HEARING DATE: September 15, 2022
 (Continued from: August 18, and Sept. 1 2022)
 TO: Planning & Zoning Commission
 FROM: Sonya Allen, Associate Planner
 208-884-5533
 SUBJECT: Kingstown
 H-2022-0045
 LOCATION: 2610 E. Jasmine St., generally located in the south 1/2 of Section 32, T.4N., R.1E. (Parcel #R4582530400)

Annexation of 8.20 acres of land with an R-8 zoning district; and preliminary plat consisting of 28 building lots and 6 common lots on 8.20 acres of land in the R-8 zoning district for Kingstown Subdivision.

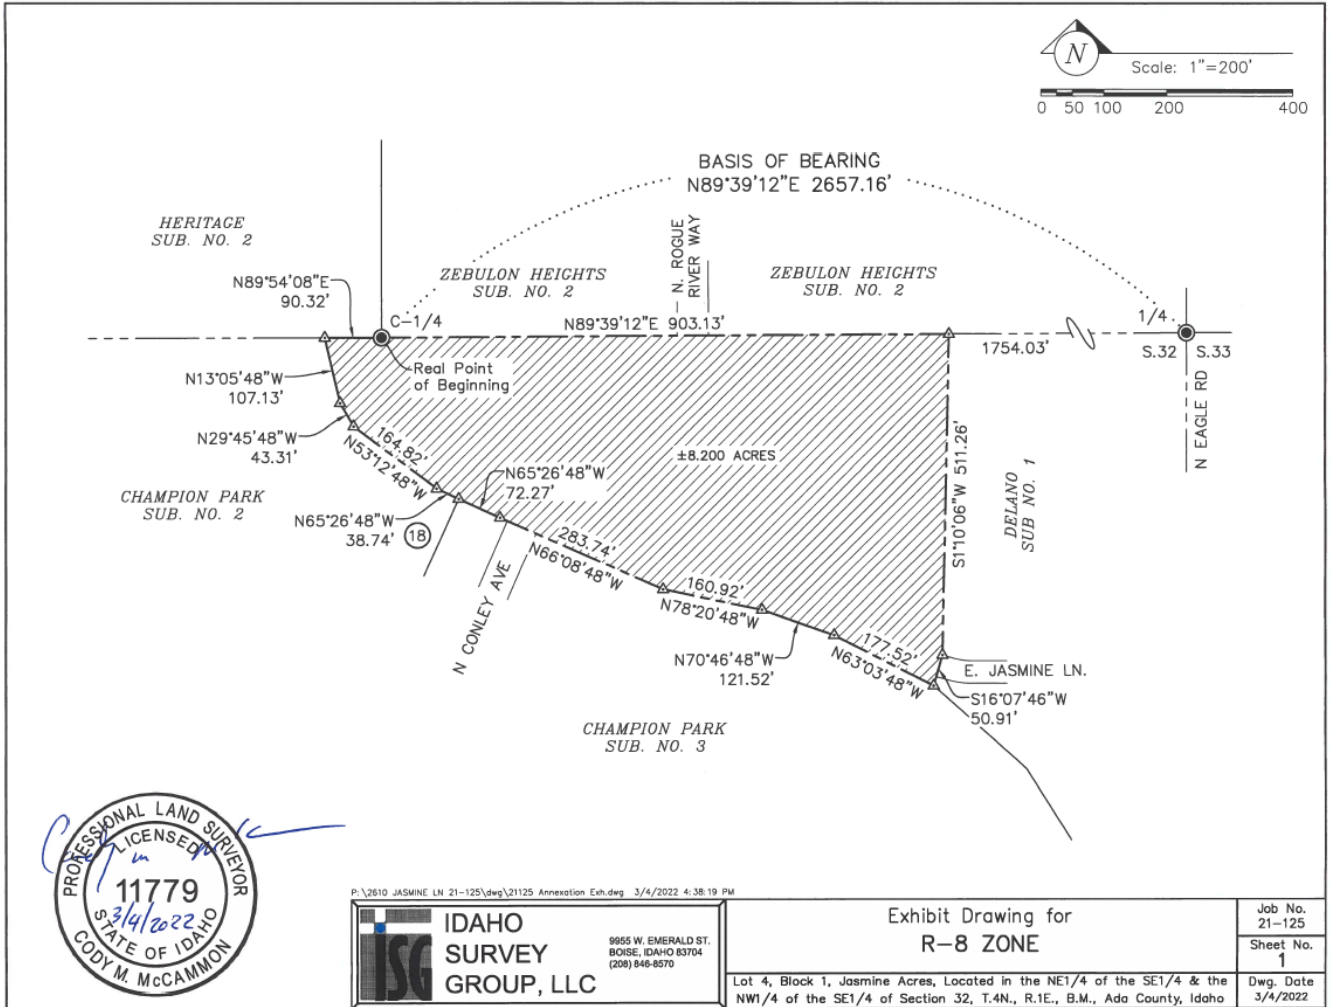
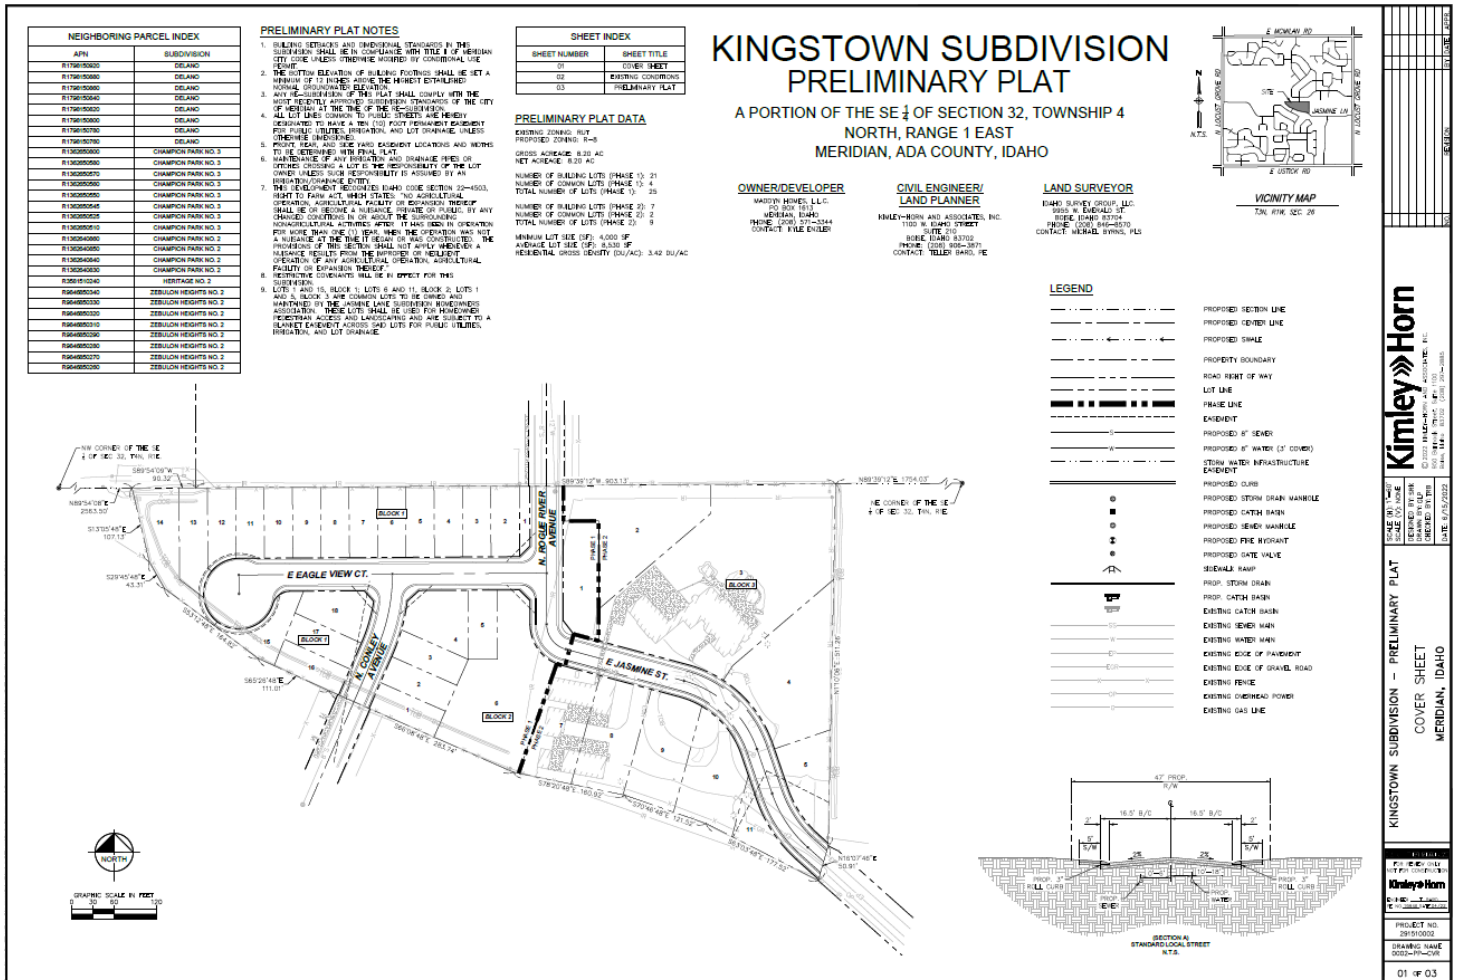
Although the gross density for the overall development at 3.42 units/acre is within and at the low end of the desired density range in the MDR designation, the lot sizes proposed in the first phase along the north boundary are not compatible in size and provide a poor transition to existing lots. The proposed lots in Phase I are mostly 4,000 square feet (or 0.09 acre), while the abutting existing lots in Zebulon Heights and Champion Park subdivisions are 0.25+ acre in size. The transition from proposed to existing homes along the north boundary range from a 2:1 to a 5:1 transition. A better transition in lot sizes should be provided. No buffering or screening is proposed.

The lot sizes proposed along the eastern boundary in Phase II are much larger/wider and range from a 1:1 to 1:4 transition. A better transition in lot sizes should be provided in this area as well. No buffering or screening is proposed.

Per the discussion in Section VI, Staff recommends the Applicant reconfigure the lots along the north boundary in Phase I so that wider and fewer lots are provided in that area; and the lots in Phase II are reconfigured and lots are added so that lots are smaller and narrower for a better transition to existing abutting properties. Conceptual building elevations should also be submitted for the 40-foot wide lots that fit on the lots. The plat, conceptual elevations and other associated plans shall be revised accordingly & submitted at least 15 days prior to the City Council hearing. Conceptual elevations and a draft of the revised plat should be submitted to Staff prior to the Commission hearing demonstrating how these changes would affect the overall density and transition to adjacent properties.

2. The final plat shall include the following revisions:
 - a. Depict an easement for the Nourse Lateral, which runs off-site along the northern boundary of this property, if it encroaches on this property.

- b. Depict a minimum 20-foot wide common lot along the south side of Lot 1, Block 2 for a multi-use pathway connection from Conley Ave. through the common areas on Lot 6, Block 2 and Lot 1, Block 3 to the pathway along the east side of Rogue River Ave. *See Park's Department comments & diagram in Section IX.E.*

C. Landscape Plan (dated: 6/16/2022)

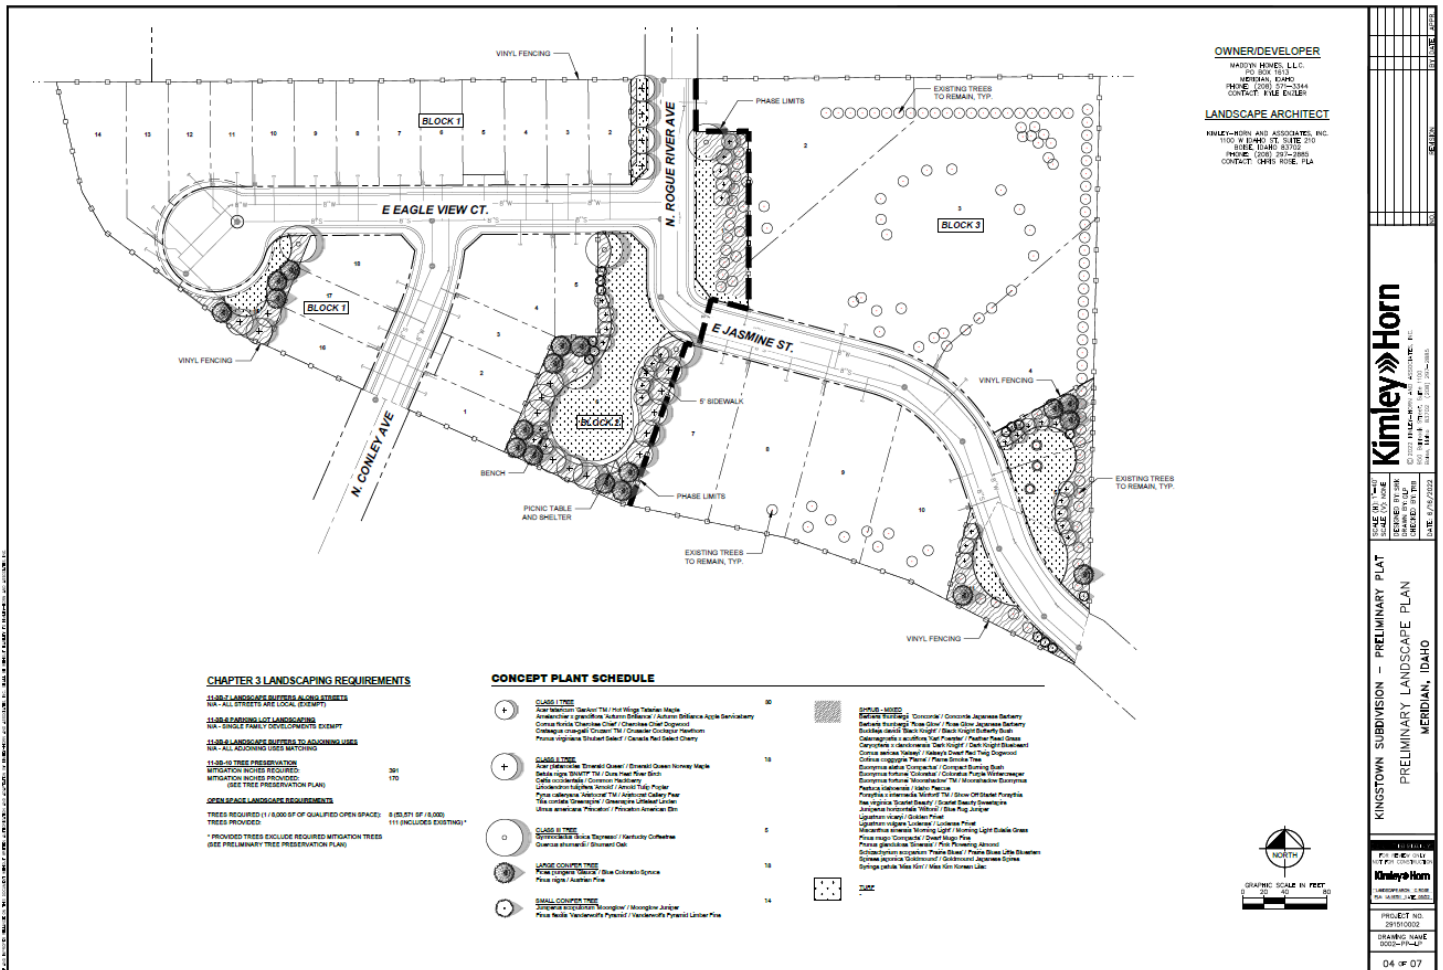
Landscaping is required along all pathways per the standards listed in UDC [11-3B-12C](#); the landscape plan should be revised accordingly.

- b. Provide one (1) 2-inch tree in the front and back yards of all building lots and an additional 109 caliper inches of trees on the site in common areas in accord with the mitigation standards listed

- c. Depict a detached sidewalk with an 8-foot wide parkway and landscaping per the standards listed in UDC 11-3B-7C on Lot 1, Block 1 in order for the lot to count toward the minimum qualified open space requirement.

D. Existing Tree Inventory & Plan

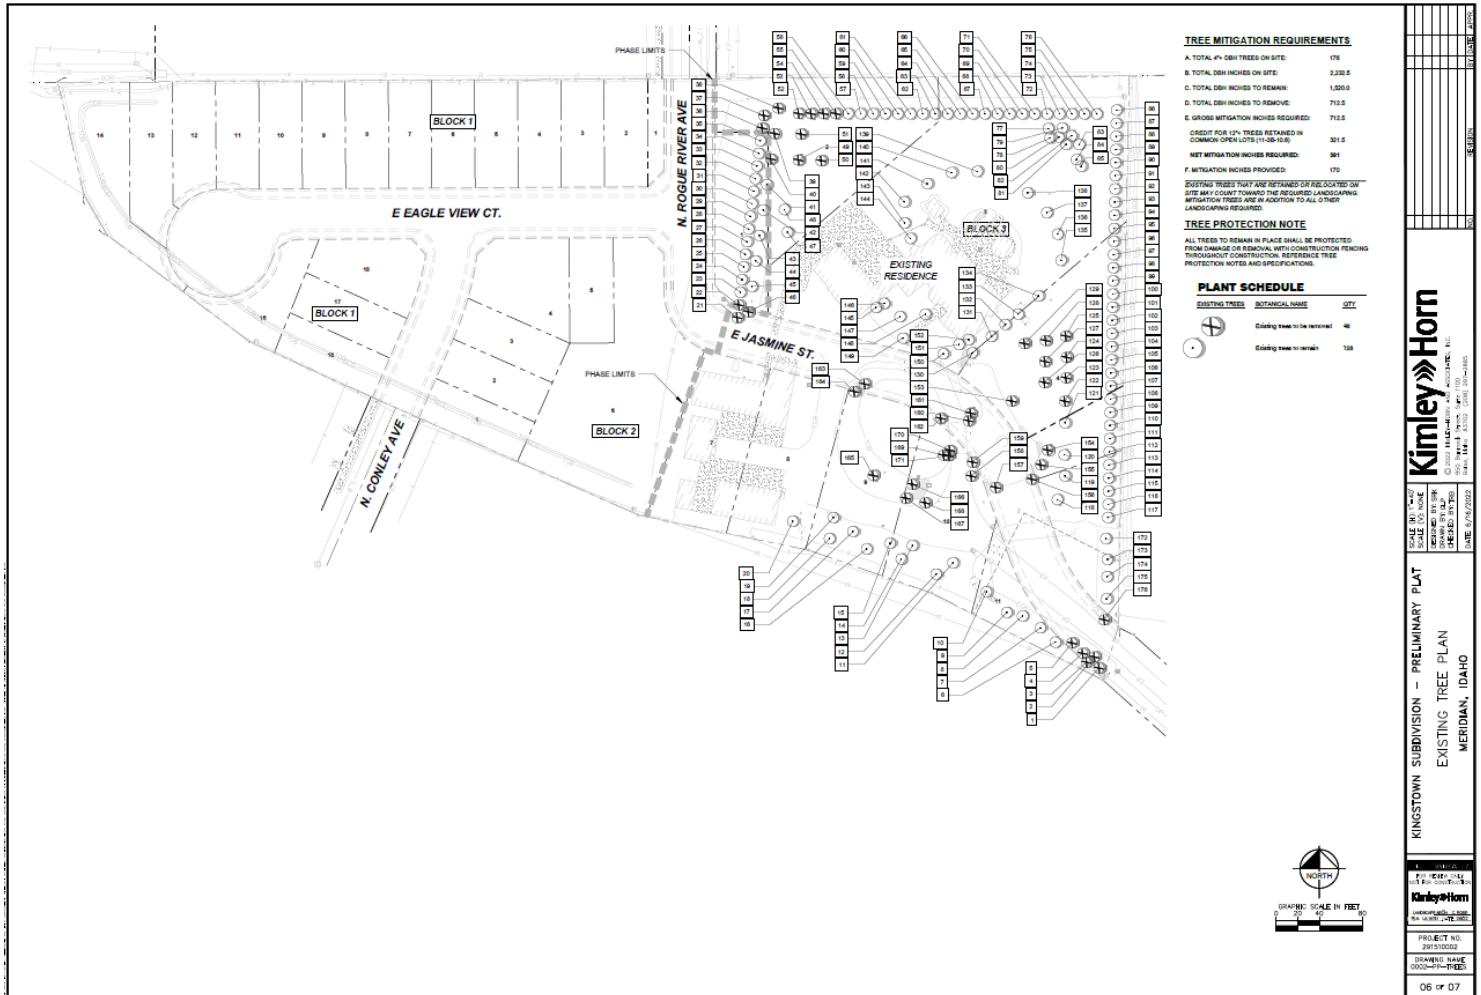
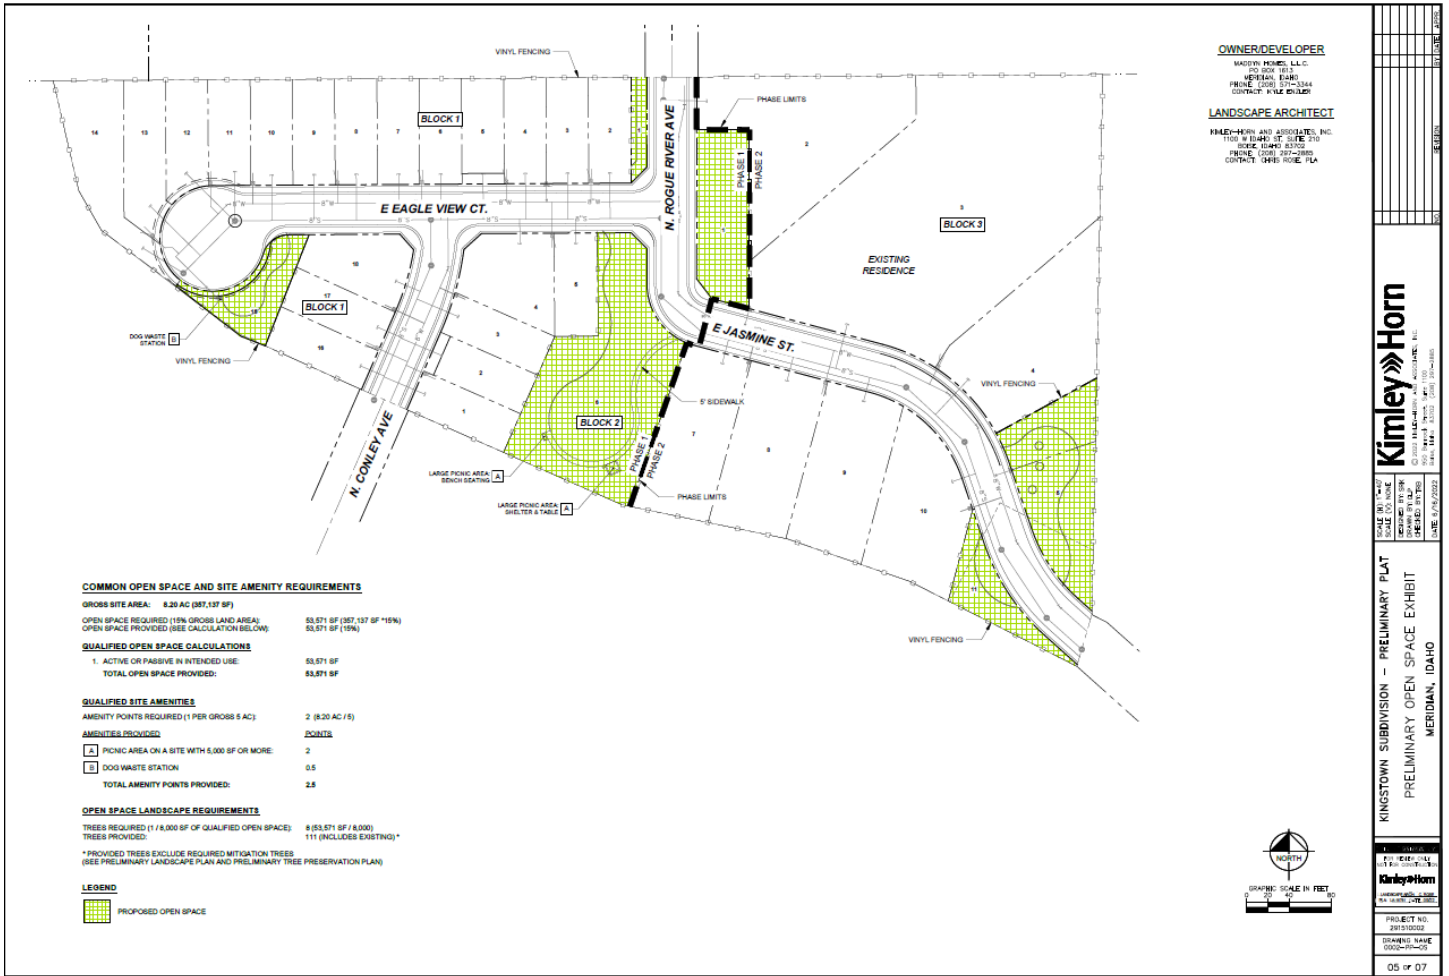
There is a total of 176 existing trees on the site totaling 2,232.5 caliper inches (see existing tree inventory and plan in Section VIII.D). A total of 1,520 caliper inches are proposed to remain with 712.5 caliper inches proposed to be removed. **A total of 391 caliper inches are required for mitigation as set forth in UDC [11-3B-10C.5](#); a total of 170 is provided, which is 221 less than required. Staff recommends one (1) 2-inch caliper tree is provided in the front and back yards of each building lot toward the mitigation requirement, which would leave 109 caliper inches remaining that could be provided in common lots, or Alternative Compliance could be requested to this standard for the remaining mitigation trees (see UDC 11-5B-5 for more information).**

E. Open Space Exhibit (dated: 6/16/22)

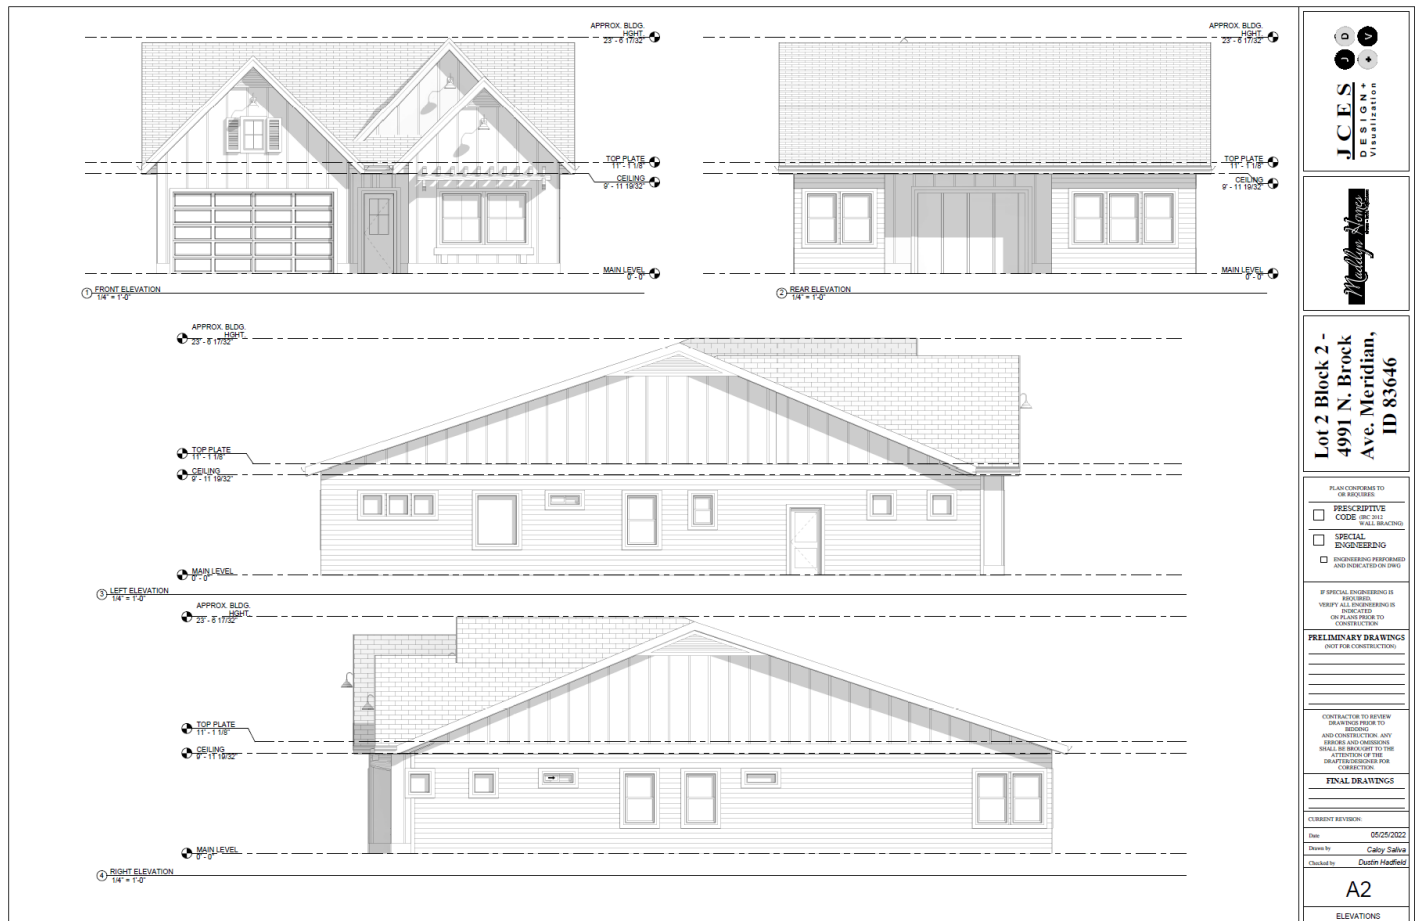
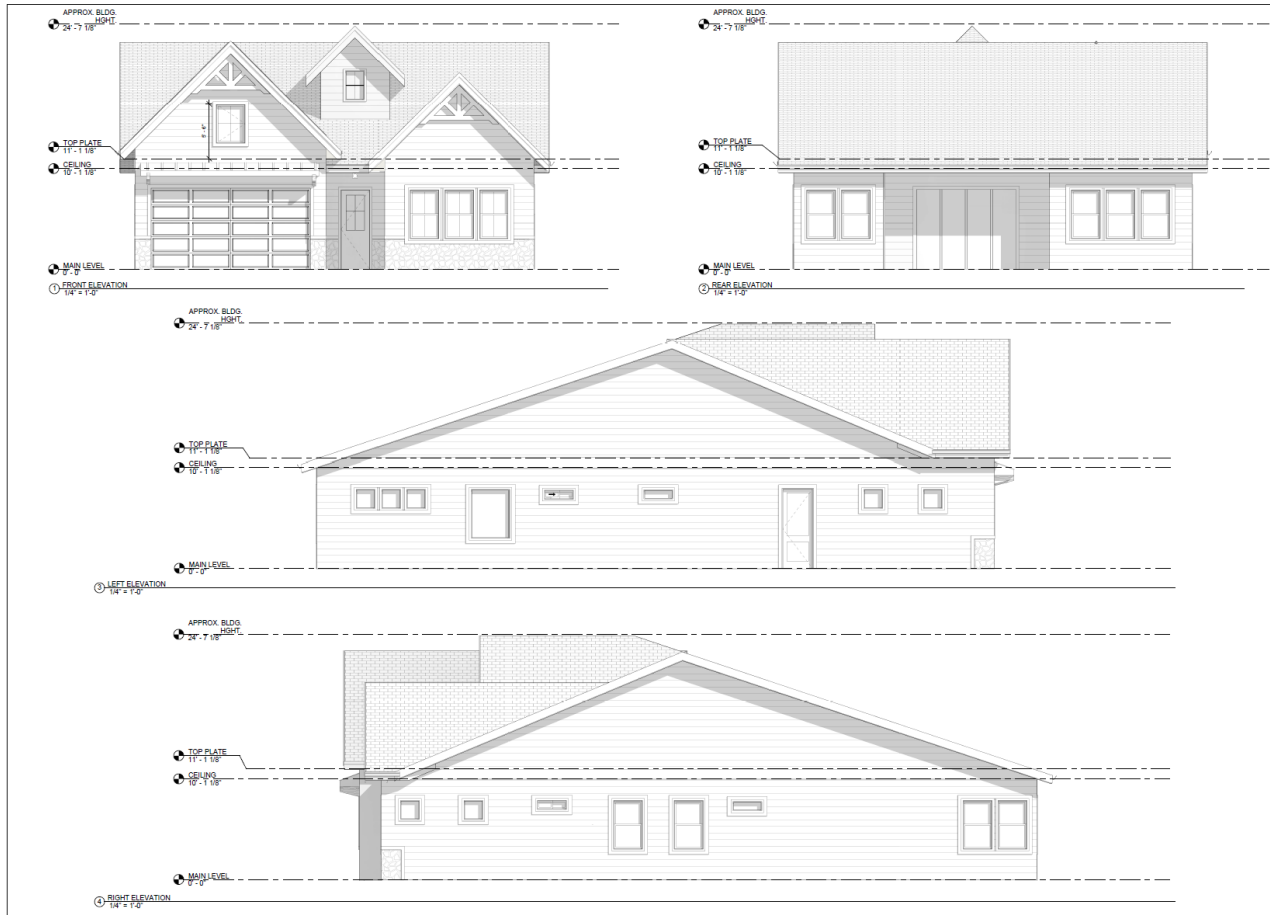
An open space exhibit was submitted that depicts 1.23 acres (15%) common open space for the development (see Section VIII.E). Three (3) of the six (6) common open space lots (i.e. Lot 6, Block 2 and Lots 1 & 5, Block 3) are open grassy areas of at least 5,000 square feet (s.f.) in area and qualify toward the minimum standards. **Lot 1, Block 1 does not qualify; however, if the sidewalk is detached in this lot and an 8-foot wide landscaped parkway is provided, it would qualify per UDC 11-3G-3B.4.**

Although Lot 15, Block 1 and Lot 11, Block 2 meet most of the *quality* standards for open space areas listed in UDC 11-3G-3A, these areas do not demonstrate integration into the development as a priority and appear to be “leftover” areas that aren’t developable as building lots and don’t meet the *qualified* open space standards listed in UDC [11-3G-3B](#). Lot 15, Block 1 could qualify toward the open space requirement if an additional 70 s.f. is added to the lot in accord with UDC 11-3G-3B.1a. Lot 11, Block 2 could qualify if 715 s.f. is added to the common lot in accord with UDC 11-3G-3B.1a; or, a community garden could be added to the existing lot in accord with UDC 11-3G-3B.1; or, a minimum 20’ x 20’ plaza could be added to the existing lot, including hardscape, seating, lighting in accord with UDC 11-3G-3B.1. The plans should be revised as recommended by Staff to meet the minimum qualified open space standards.

- d. Increase the size of Lot 15, Block 1 by 70 square feet to meet the qualified open space standard of 5,000 square feet in UDC 11-3G-3B.1a.
3. The landscape plan submitted with the final plat shall include the following revisions:

- e. Increase the size of Lot 15, Block 1 by 70 square feet to meet the qualified open space standard of 5,000 square feet in UDC 11-3G-3B.1a.
 - f. Lot 11, Block 2 does not meet the qualified open space standards listed in UDC 11-3G-3B – the plans should be revised to comply through one of the following options: 1) add 715 s.f. to the common lot in accord with UDC 11-3G-3B.1a; or, 2) include a community garden in the common lot; or, 3) include minimum 20' x 20' plaza in the common lot, including hardscape, seating, and lighting in accord with UDC 11-3G-3B.1. *If the lot is enlarged, the plat shall also be amended accordingly.*
